REVISIONS	APPROVALS
9 REDLINE NO.9 4/29/98	ASST. DIV. CHIEF, SIGNAL DESIGN SECTION
	ASST. DISTRICT ENGINEER, TRAFFIC
	CHIEF, TRAFFIC ENGINEERING DESIGN DIVISION
	DEPUTY CHIEF ENGINEER, OFFICE OF TRAFFIC

DMP/DCI RAC BAL TH
© RECONSTRUCT SIGNAL SHA PROJECT NO. HO-661-701-770
LSC DCI

ORIGINAL DRAWN BY	R CICCHINI / J ALLEN	MD 108 AT MD 104	
DES. BY	S CHERNACK / D PETERS		
CHK. BY	Bruce Thompson 11-14-96	LOG MILE NO.	COUNTY: HOWARD
DATE: 10/96	F.A.P. NO. SEE TITLE SHEET	TS/FILE NO. 1589-C	SHEET NO. 419 OF 529
SCALE: 1"=20'	S.H.A. NO. HO-661-502-770

SIG-8 TEMPORARY SIGNAL #4 PHASE ~~III~~ II

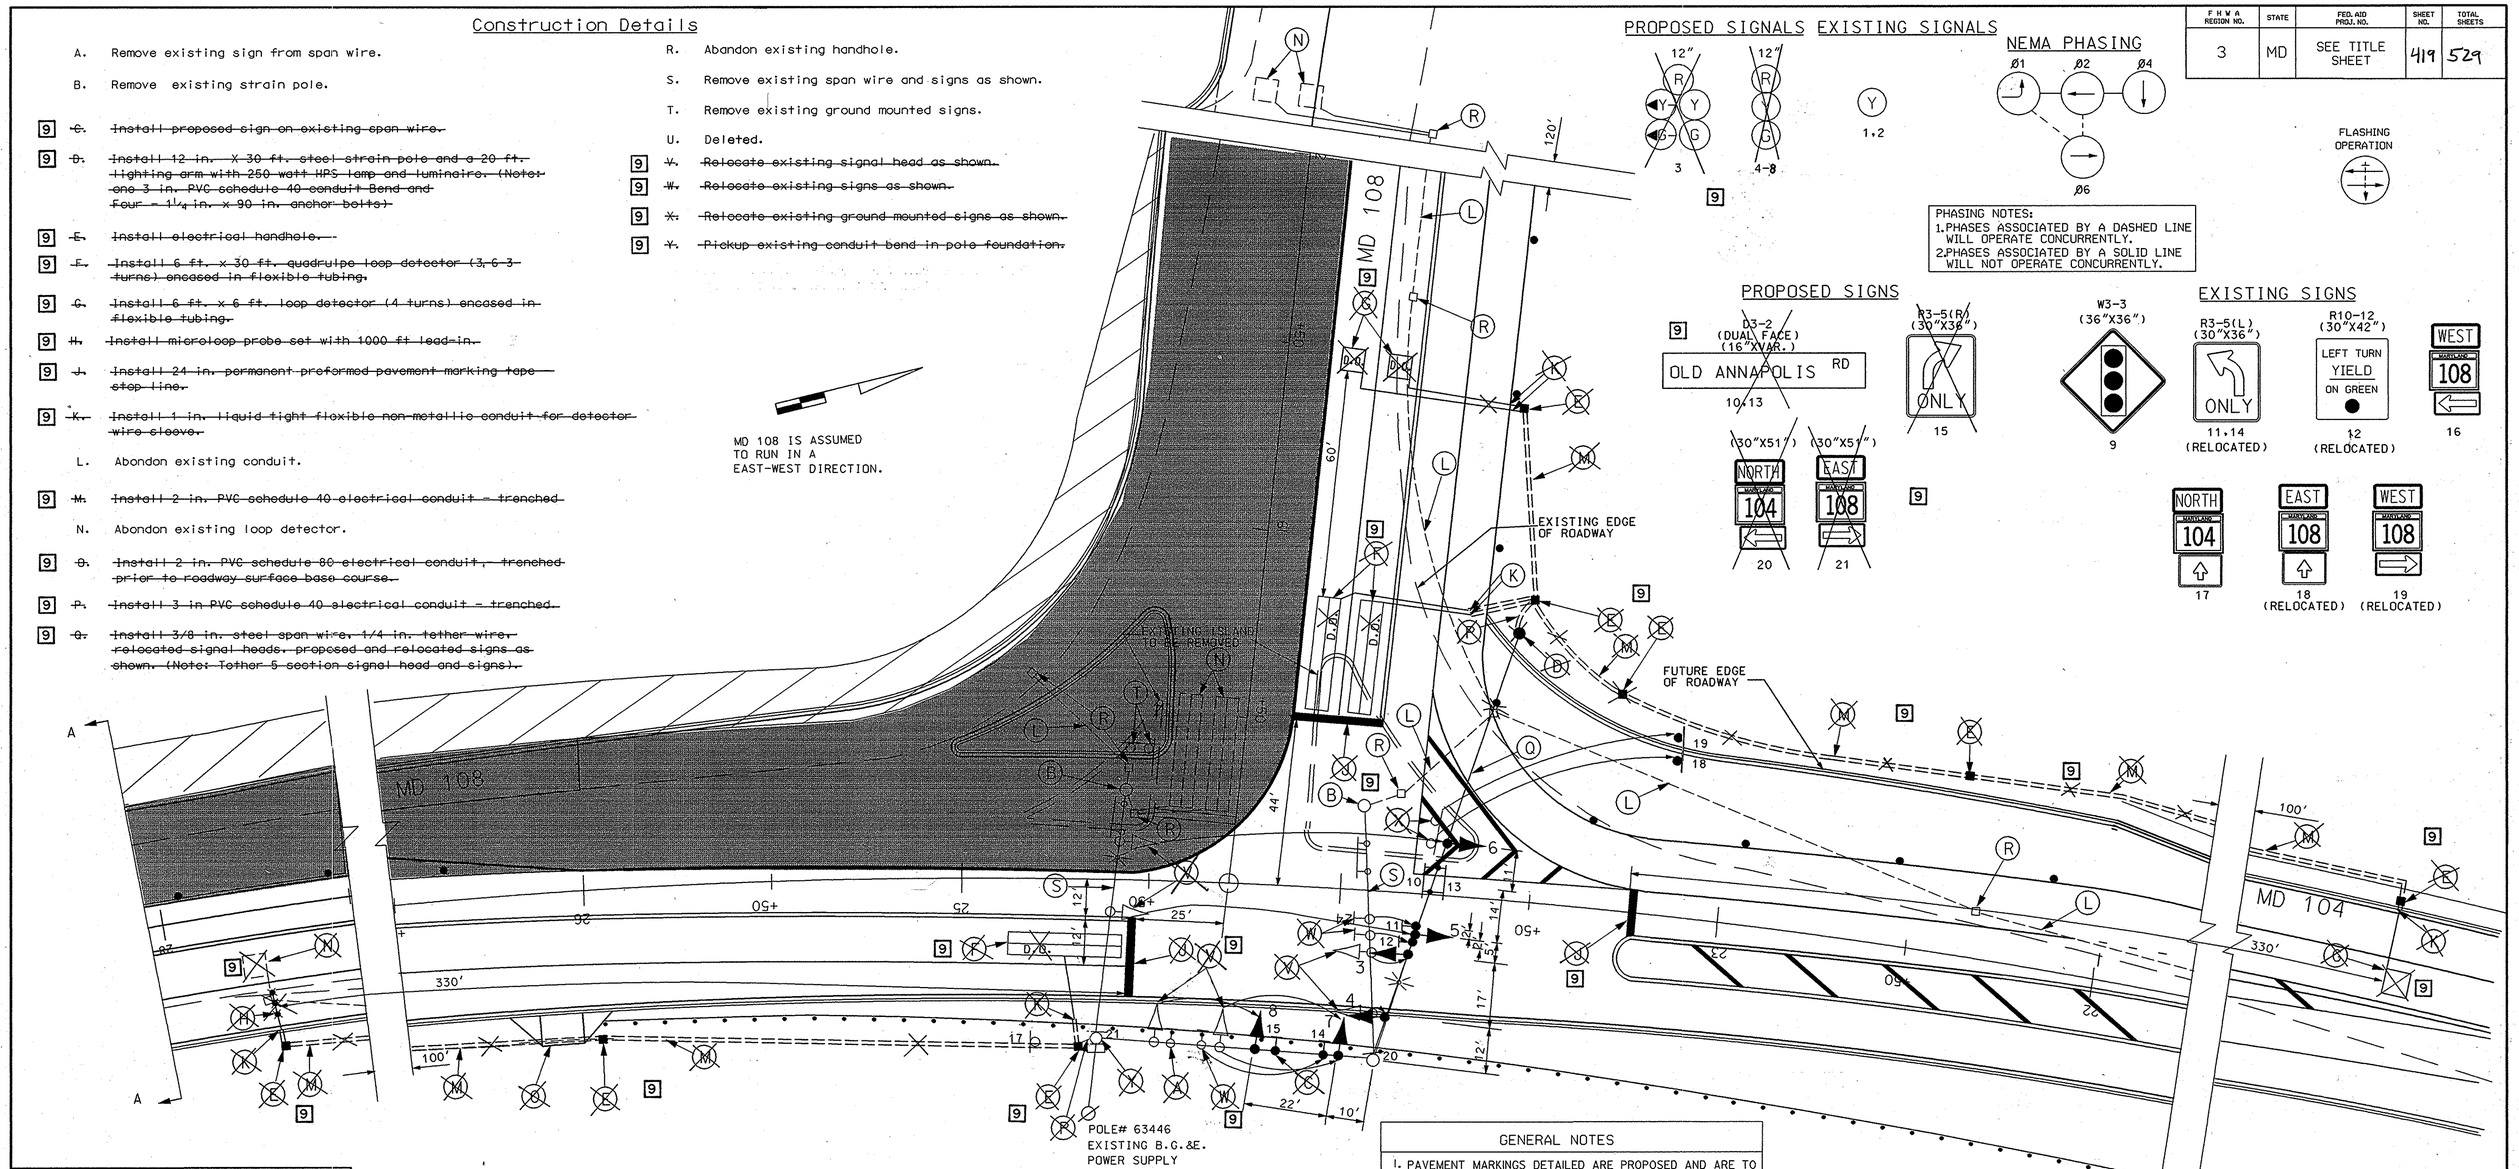
9 ~~C. Install proposed sign on existing span wire.~~

9 ~~D. Install 12 in. X 30 ft. steel strain pole and a 20 ft. lighting arm with 250 watt HPS lamp and luminaire. (Note: one 3 in. PVC schedule 40 conduit Bend and Four - 1¼ in. x 90 in. anchor bolts).~~

9 ~~E. Install electrical handhole.~~

9 ~~F. Install 6 ft. x 30 ft. quadrulpe loop detector (3,6-3 turns) encased in flexible tubing.~~

9 ~~G. Install 6 ft. x 6 ft. loop detector (4 turns) encased in flexible tubing.~~

9 ~~H. Install microloop probe set with 1000 ft lead-in.~~

9 ~~J. Install 24 in. permanent preformed pavement marking tape stop line.~~

9 ~~K. Install 1 in. liquid tight flexible non-metallic conduit for detector wire sleeve.~~

9 ~~M. Install 2 in. PVC schedule 40 electrical conduit - trenched~~

9 ~~O. Install 2 in. PVC schedule 80 electrical conduit, trenched prior to roadway surface base course.~~

9 ~~P. Install 3 in PVC schedule 40 electrical conduit - trenched.~~

9 ~~Q. Install 3/8 in. steel span wire, 1/4 in. tether wire, relocated signal heads, proposed and relocated signs as shown. (Note: Tether 5 section signal head and signs).~~

9 ~~V. Relocate existing signal head as shown.~~

9 ~~W. Relocate existing signs as shown.~~

9 ~~X. Relocate existing ground mounted signs as shown.~~

9 ~~Y. Pickup existing conduit bend in pole foundation.~~
